Permit No: PRRES20241195
Plan Name:
Project Address: 4359 NE HIDEAWAY DR, LEES SUMMIT, MO 64064
Parcel Number: 284206

Our firm has been asked to make structural clarifications to the plans of the house to be built at the address listed above. During the permit review process the AHJ has questioned items. Below is a list of our recommendations along with the corresponding city item.

STRUCTURAL REVIEW

5

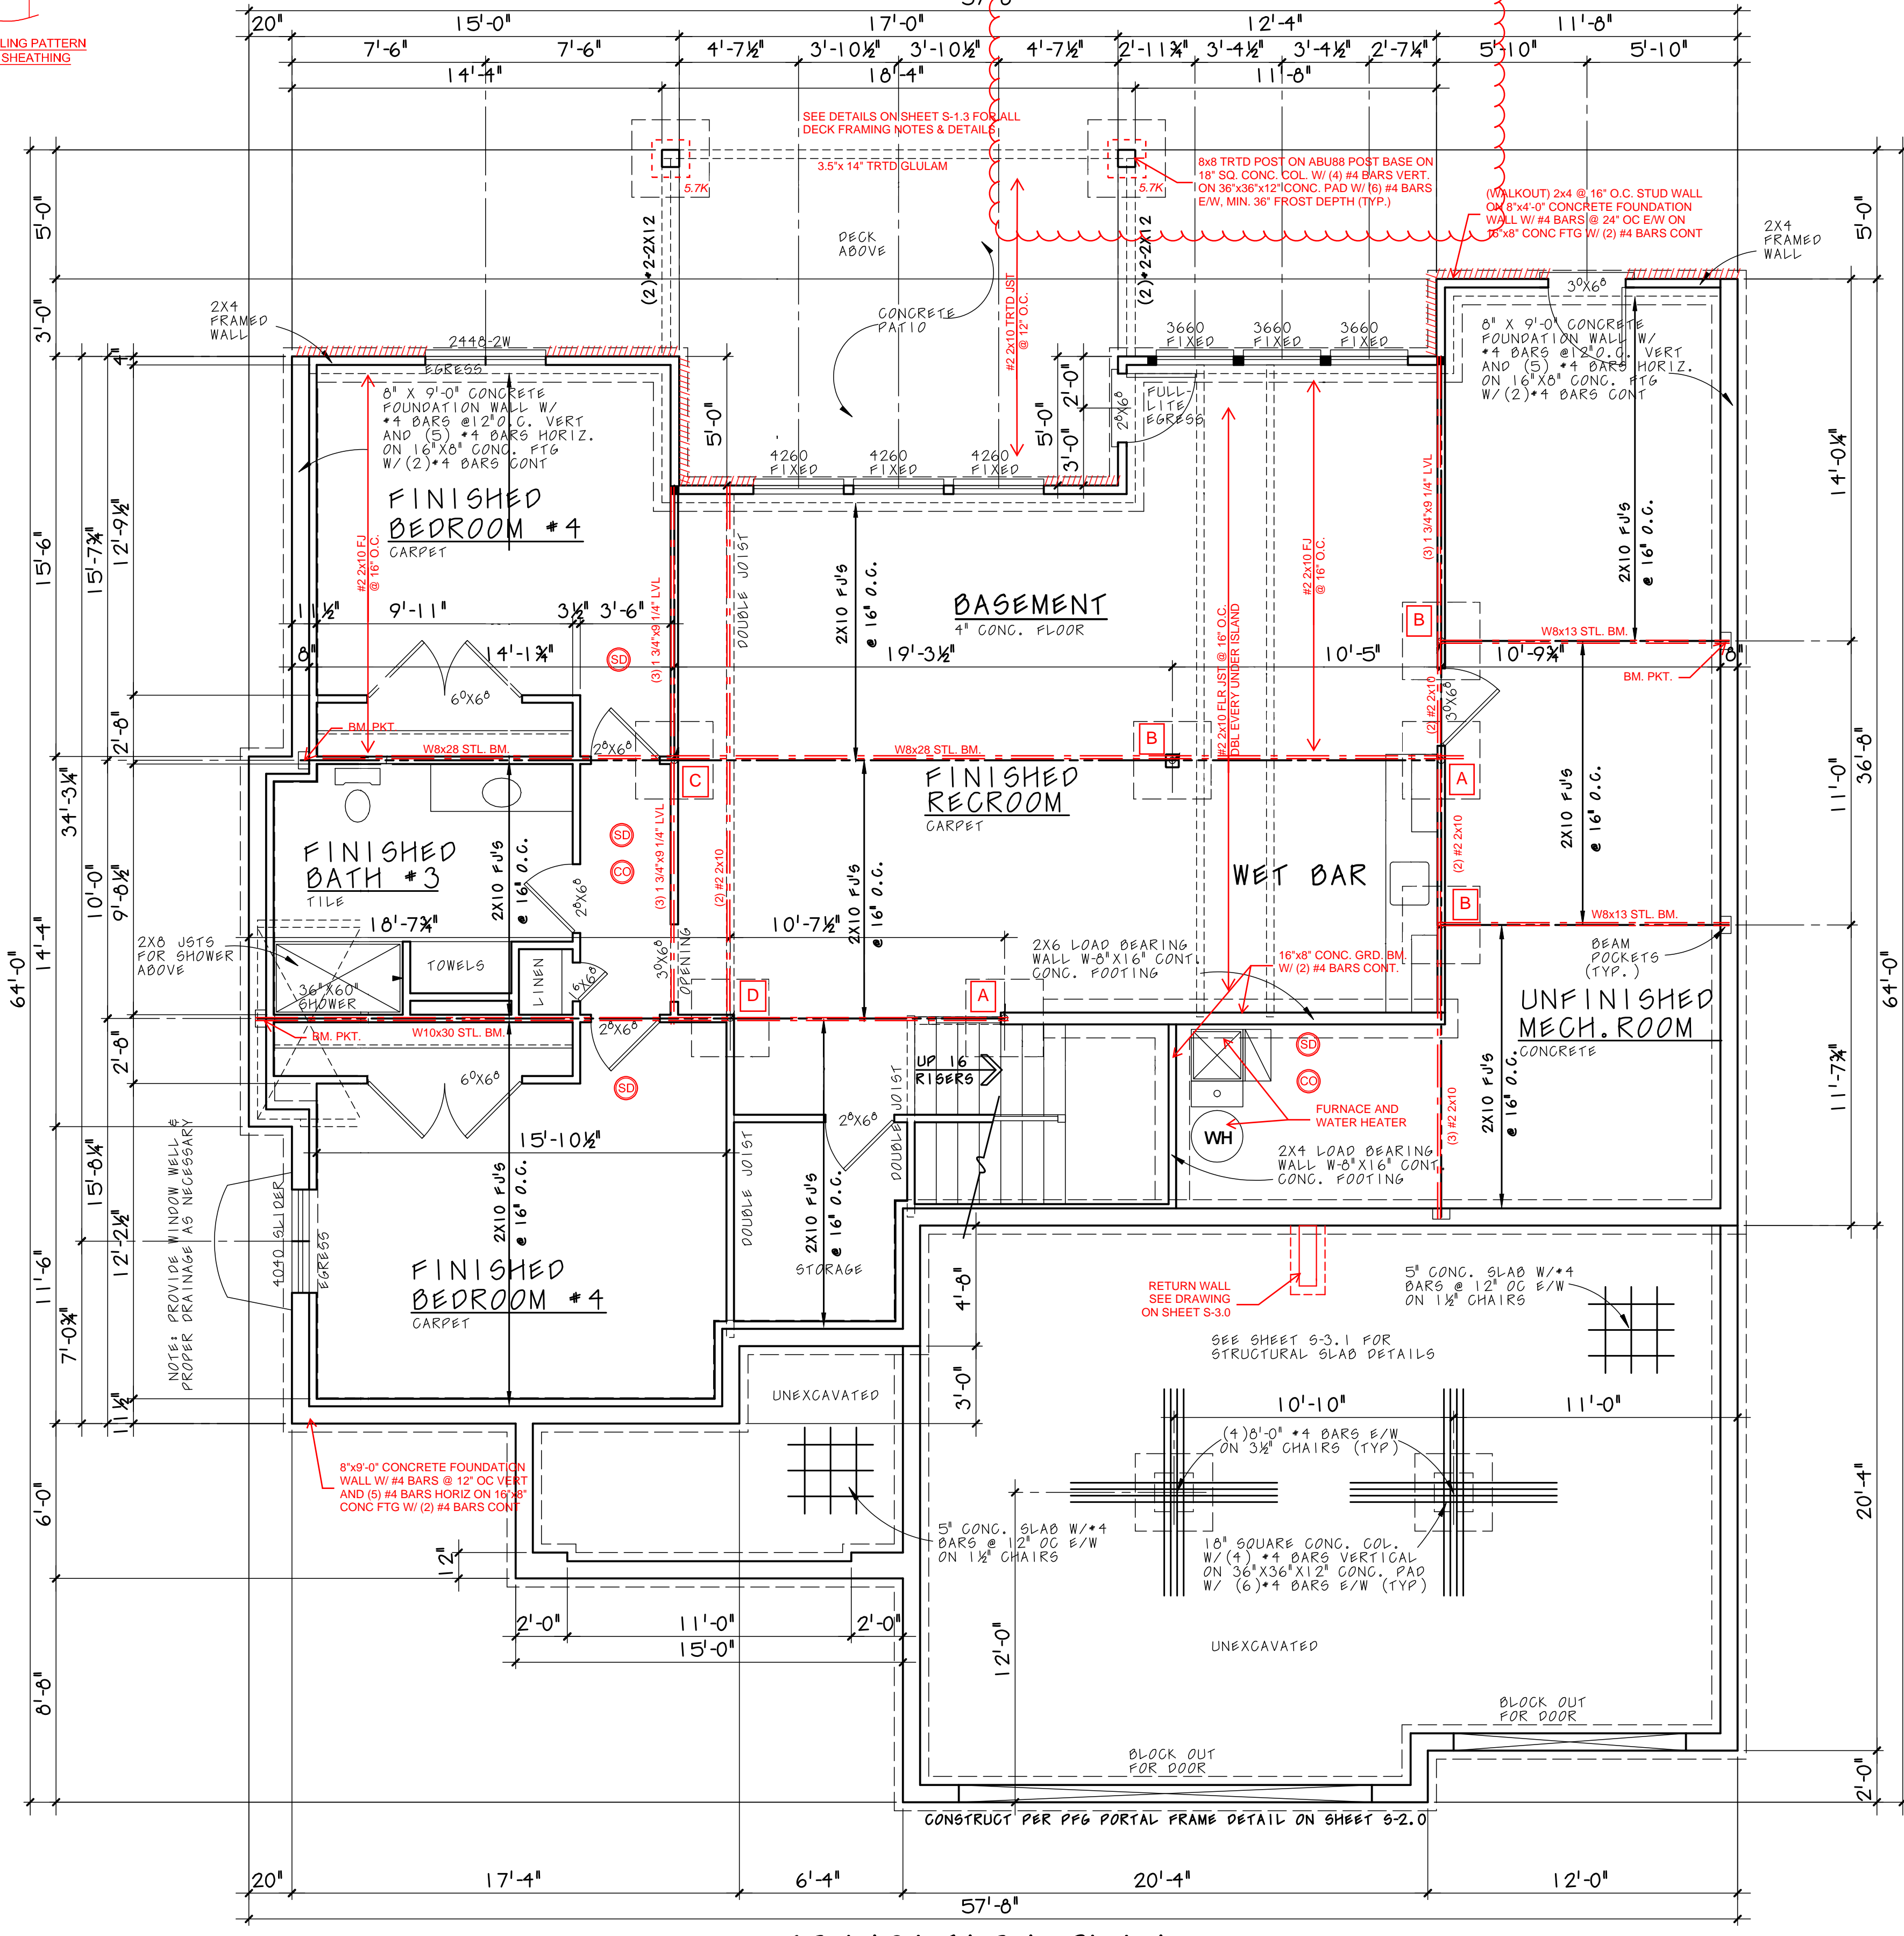
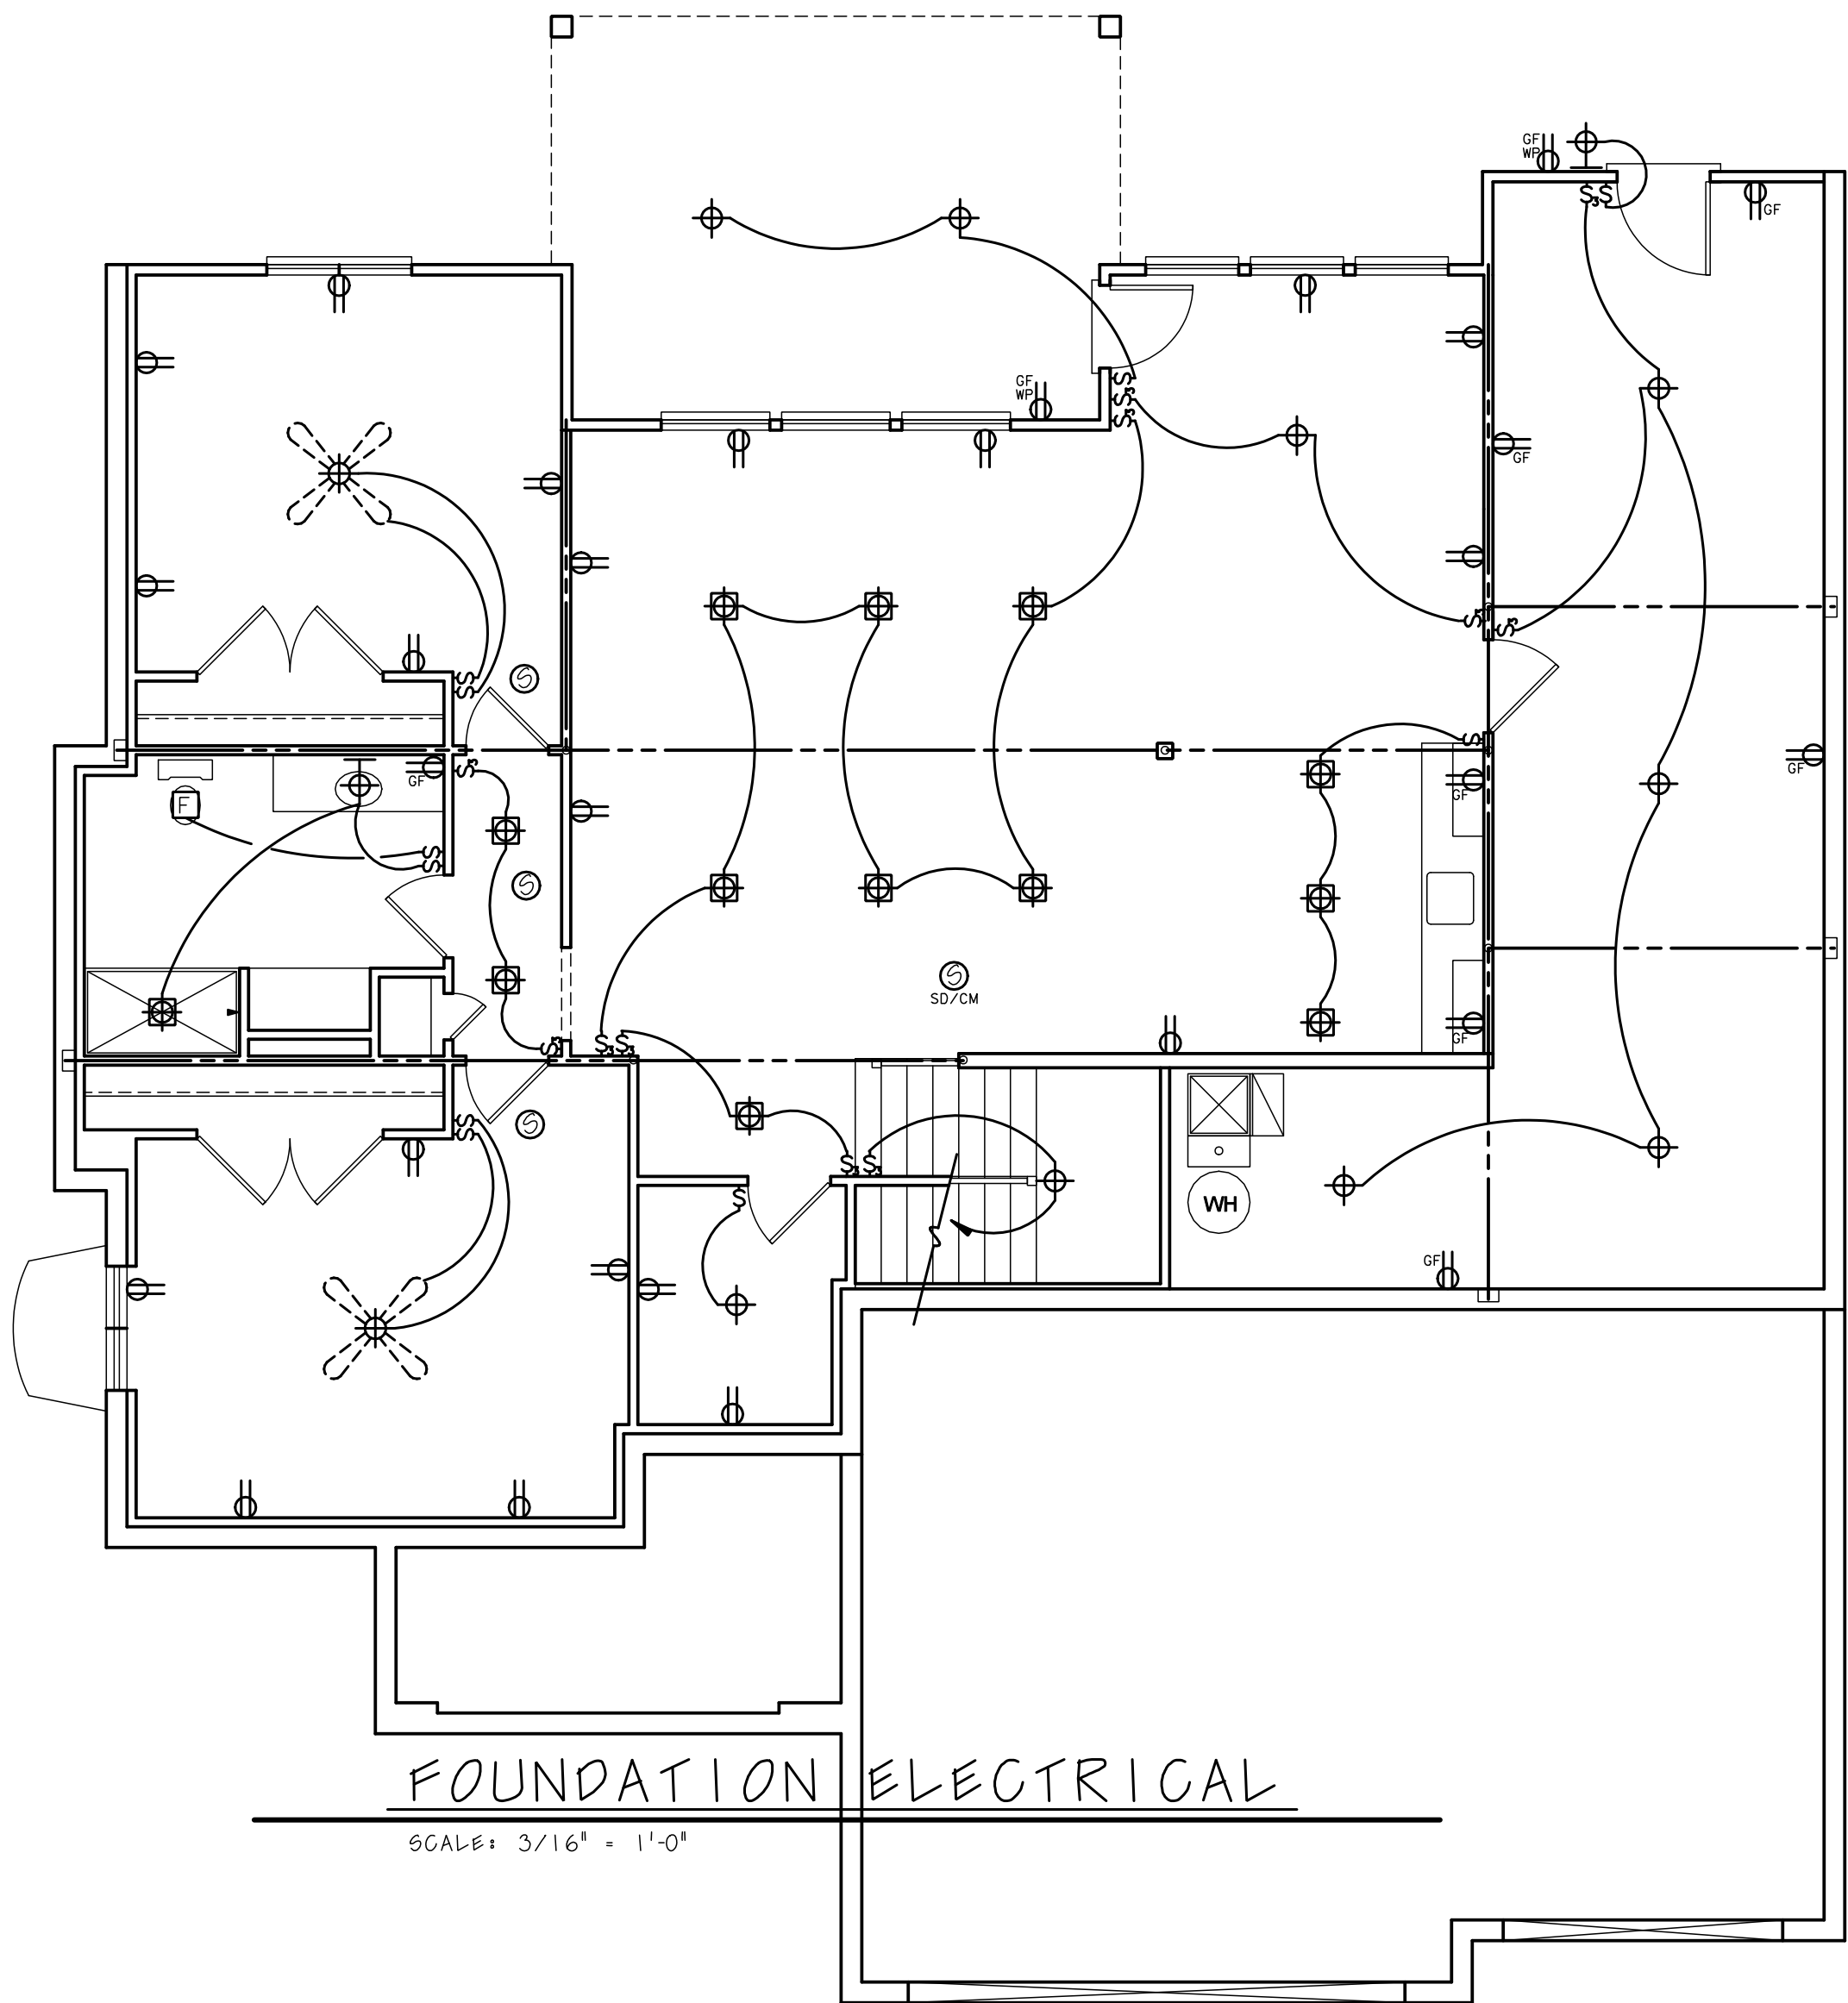
1. Provide combustion air calculations and specify transfer air grilles for fuel burning appliances located in confined space(s). (IRC Chapter 17 and Section G2407) **SEE CALCULATION ON S-1.3**
2. Footings, column pads, piers and grade beams - dimensions. (IRC Section R403) DECK PIER DETAIL NOT FOUND, SHOWS 12" DEEP PIER **SEE DETAIL AND NOTE ON SHEET 5**
3. Footings, column pads, piers and grade beams - reinforcement size and spacing. DECK PIER DETAIL NOT FOUND, SHOWS 12" DEEP PIER **SEE DETAIL AND NOTE ON SHEET 5**

PIERS TO TERMINATE ON ORIGINAL SOIL OF 1500
PSF MINIMUM BEARING.
PIERS TO TERMINATE AT A POINT 36" MINIMUM
BELOW FINISH GRADE.
POSTS ARE NOT TO EXCEED AN UNBRACED LENGTH
OF 12' WITHOUT CONTACTING HD ENGINEERING
FOR GUIDANCE.
ALL EXTERIOR STEEL SHALL BE GALVANIZED OR
WRAPPED/SEALED WEATHER TIGHT. ALL
FASTENERS SHALL BE RATED FOR APPROPRIATE
USE.
ALL TREATED WOOD SHALL BE MIN. #2 SYP.

03/20/2024 CITY COMMENTS
